AGENDA  
Village of Chenequa  
Monday, June 9, 2025  
31275 W County Road K, Chenequa, WI 53029

## STAFF REVIEW

**Subject:** Site Plan Review

**Project Description:** Proposed Accessory Structure

Shoreline Landscape	Chris Miracle, PLA, ASLA	John Klatt, PLA, ASLA	Sheet Number: 2/3	Date: 4.16.25	Rev: 5.2.25
---------------------	--------------------------	-----------------------	-------------------	---------------	-------------

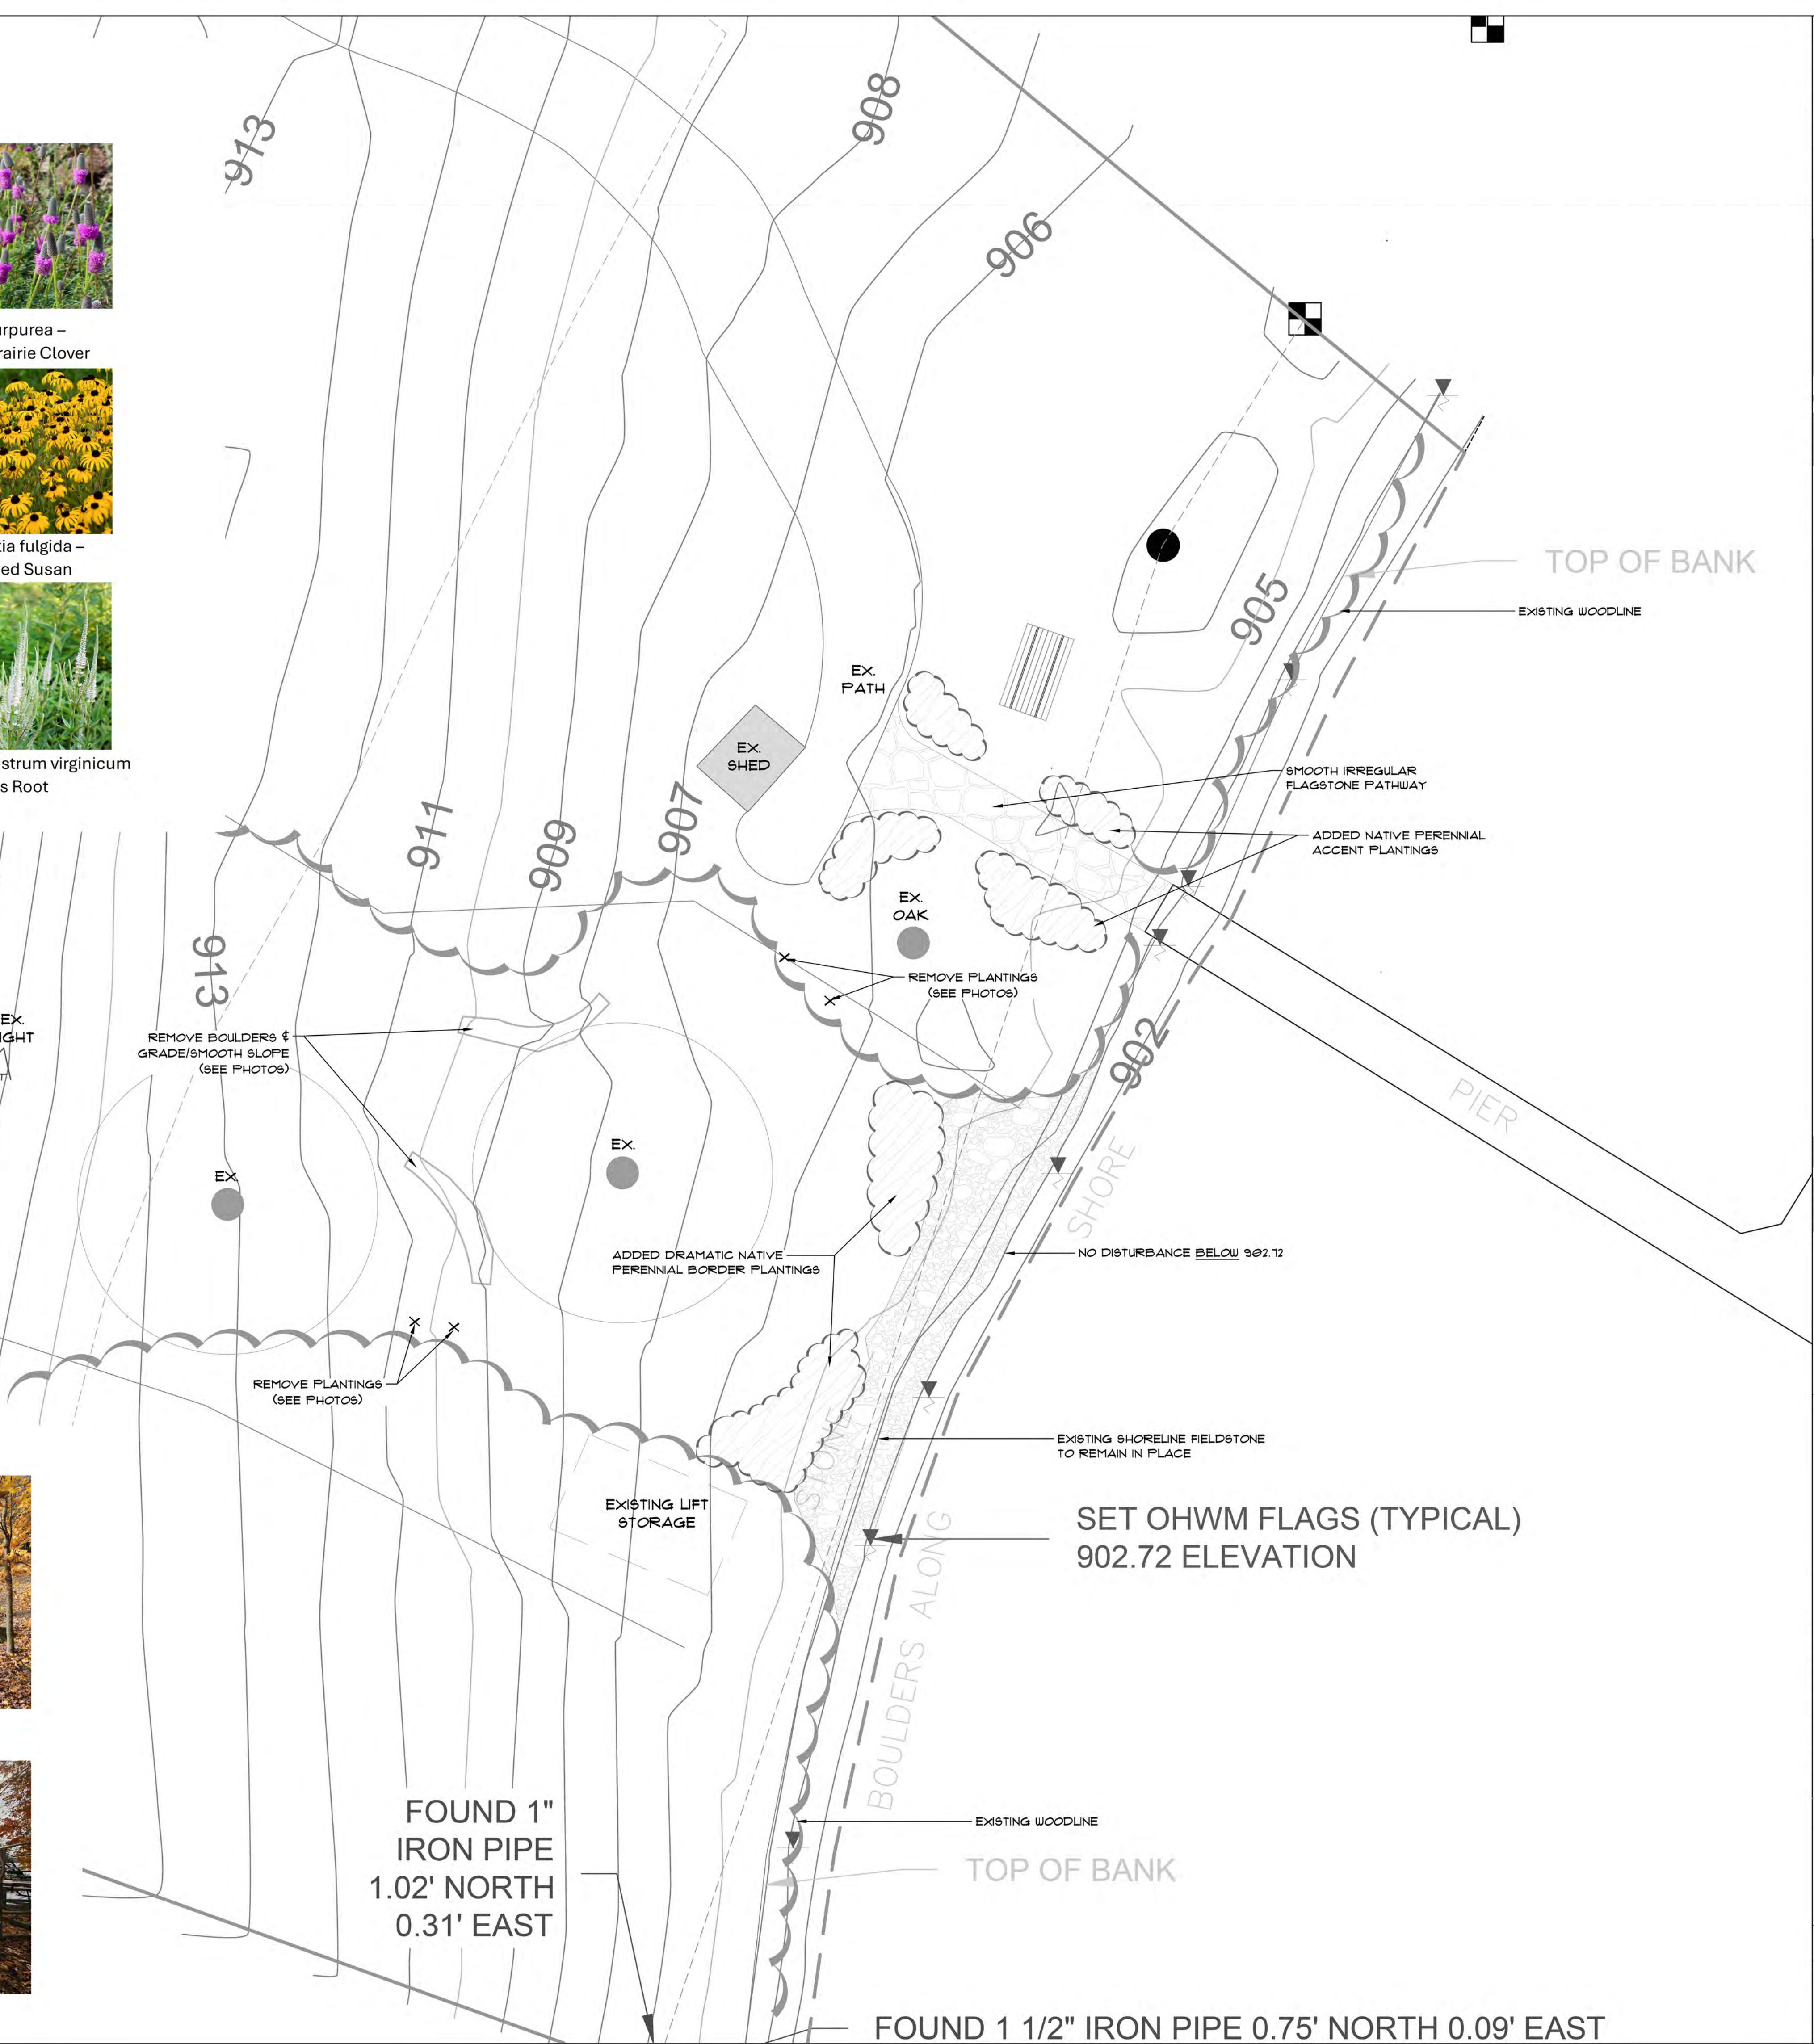
1. The applicant proposes landscaping on the lake side of the primary dwelling.
2. Plans include, adding a path, adding plantings and removing existing landscaping
  - a. Proposed path
    - i. The path is proposed to be constructed of flagstone steppers set at soil grade.
    - ii. The proposed path will connect an existing cart path to the existing pier on the property
    - iii. See landscape drawing for proposed path location.
    - iv. The proposed path will not exceed 4' in width
    - v. A photo sample has been provided in the included packet
  - b. Proposed plantings
    - i. Along the proposed path and shorefront the applicant proposes to add native perennial plantings

- ii. Proposed planting locations are provided in the landscape plan
    - iii. Photo samples of proposed plantings have been provided in the packets
  - c. Removal of existing landscaping
    - i. The landscape plan also proposes to remove existing boulders near the shorefront.
    - ii. Location of existing boulders are provided in the landscape plan
- 3. A cutting permit must be obtained by the Village Forester before existing ground cover may be removed.

SCALE: 1/8" = 1'-0"  
SHEET NUMBER: L1.1

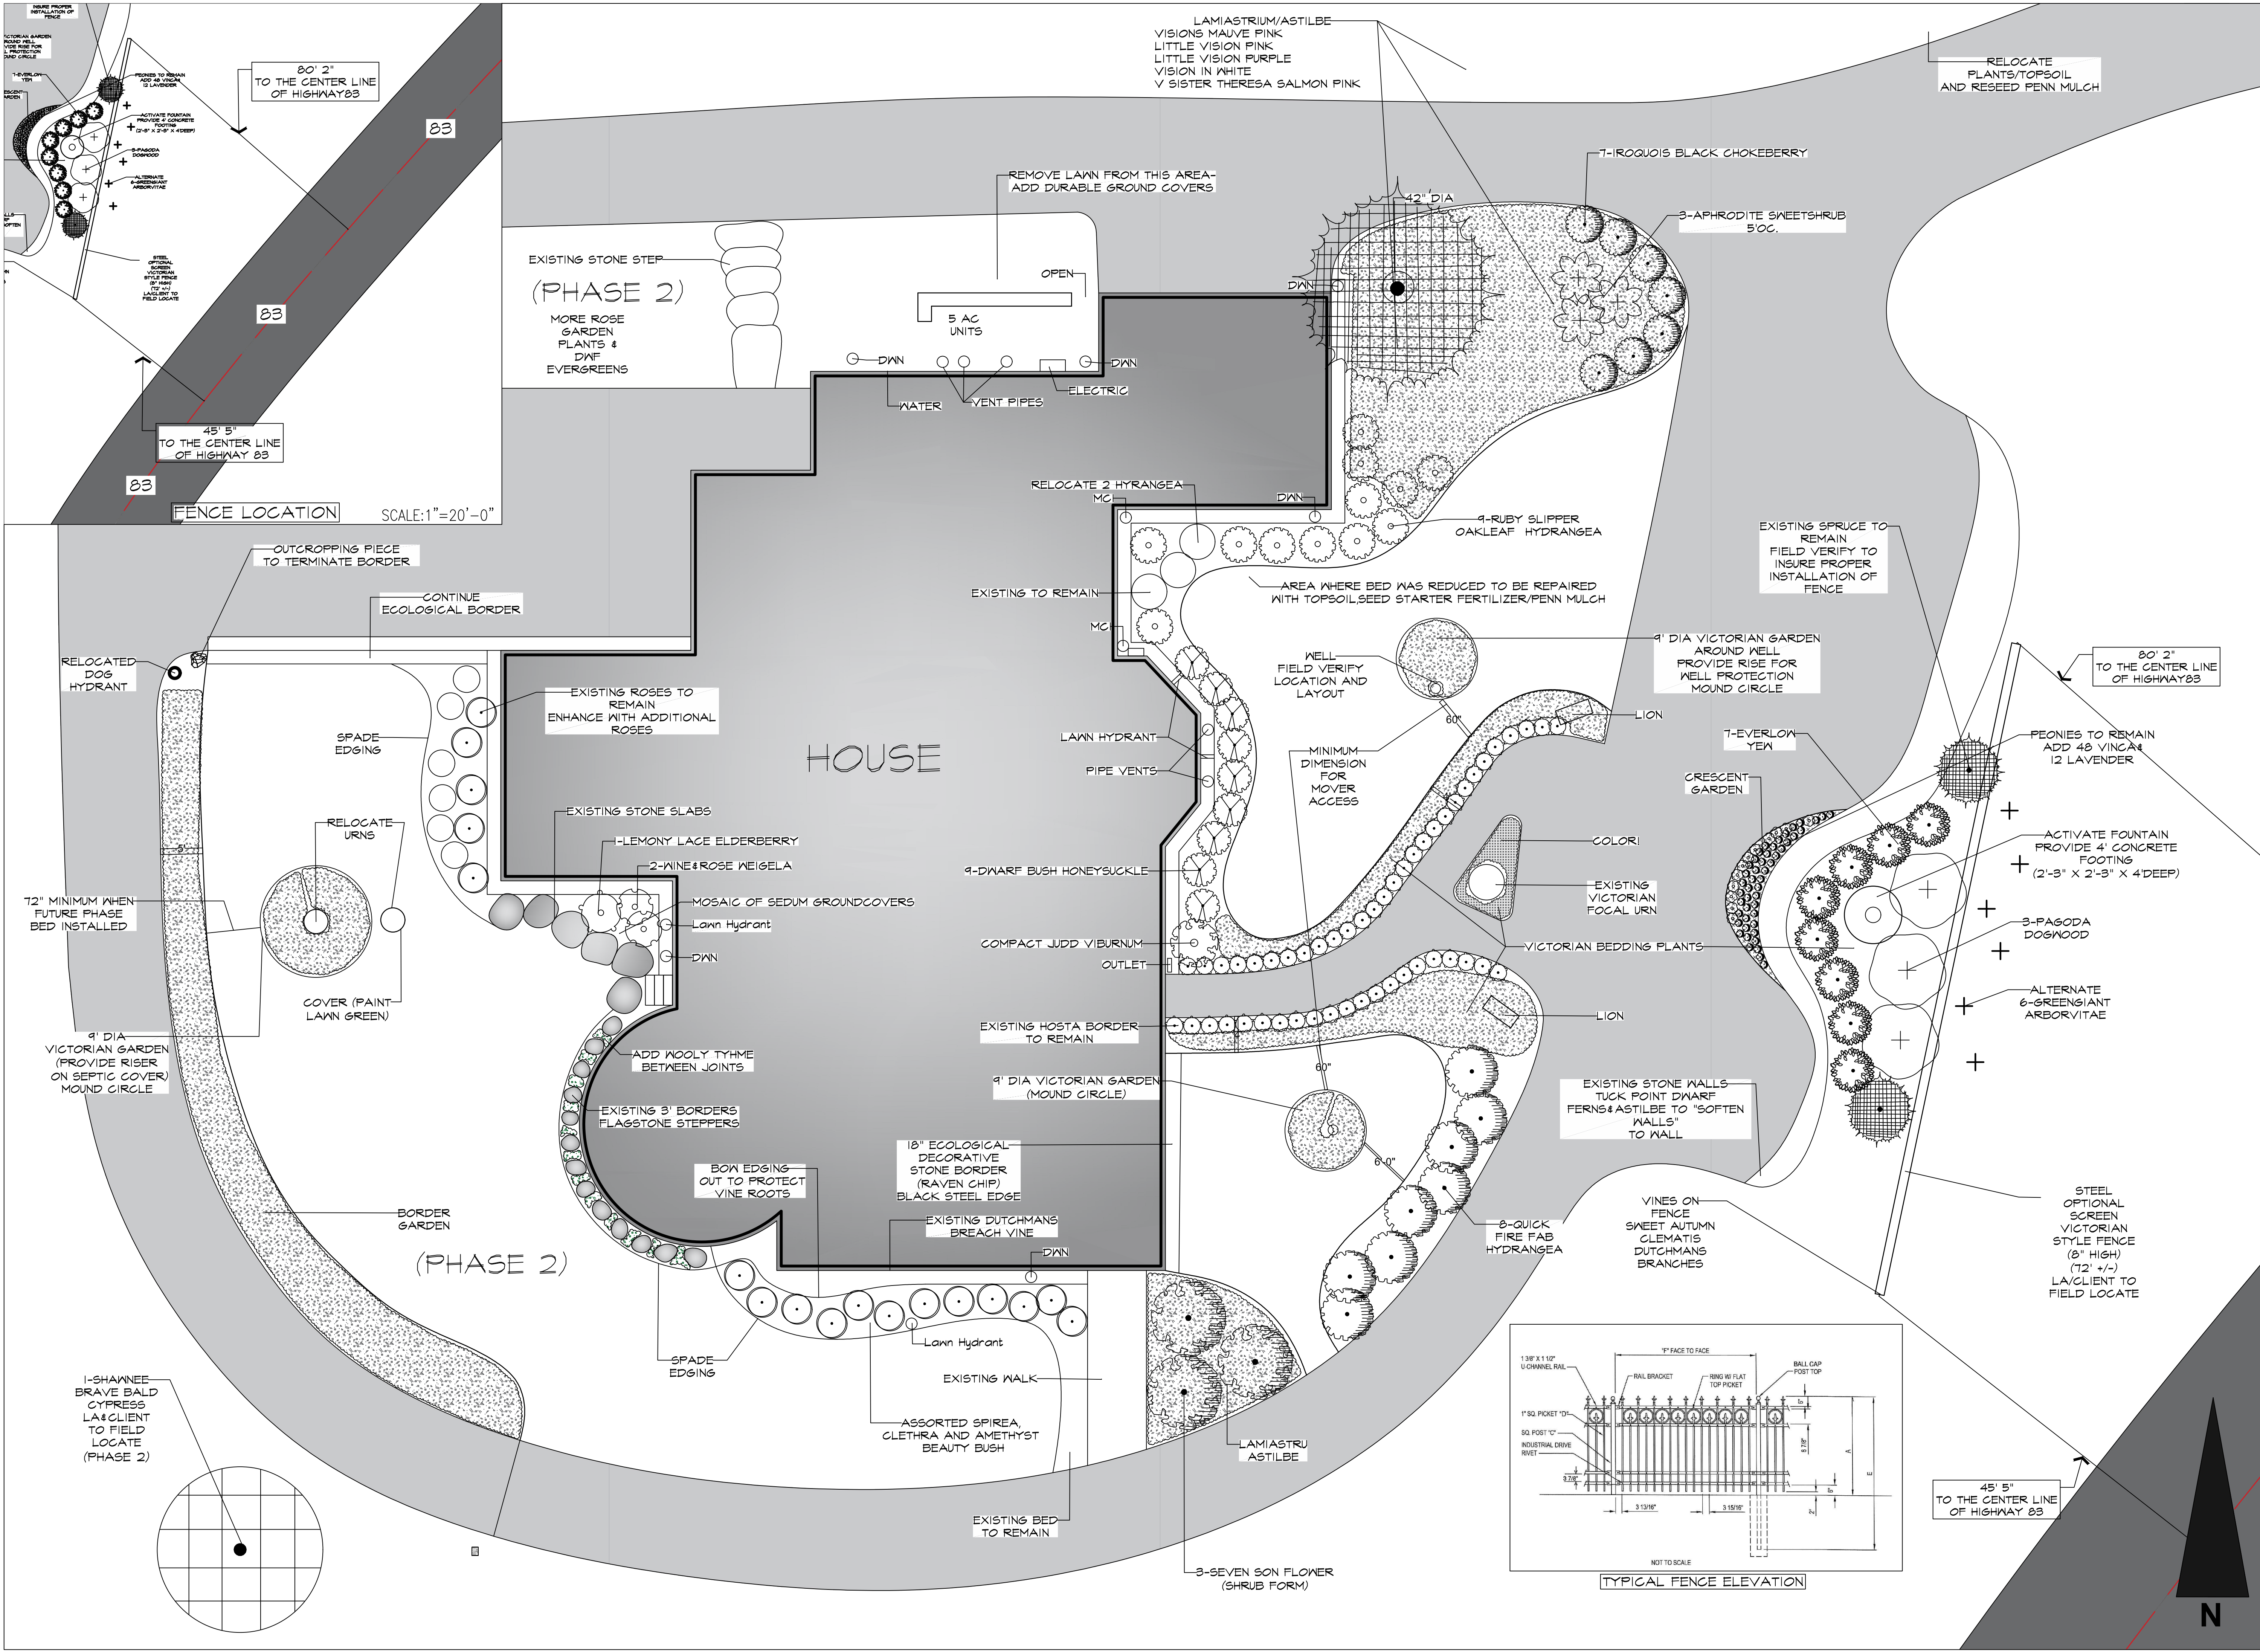
1. The applicants are proposing to construct an 8' fence along STH 83 to serve as additional screening from the road
2. According to 5.20(1) *"All permit applications shall be referred to the Plan Commission and shall be considered as to appearance, materials, design, location, height and harmony of the proposed fence with the principal structure on the lot and structures on neighboring lots so as not to adversely affect property values in the neighborhood."*

3. The fence is proposed to be a "Steel Victorian Style Fence"
  - a. A sample sketch of the proposed fence has been provided in the attached landscape plan

- b. Fence location has also been provided on the landscape plan
4. At the nearest point, this proposed fence is set back 45' 5" from the centerline of STH 83 (Approximately 12.5' feet outside of the public right of way (refer to site drawing in packet)).
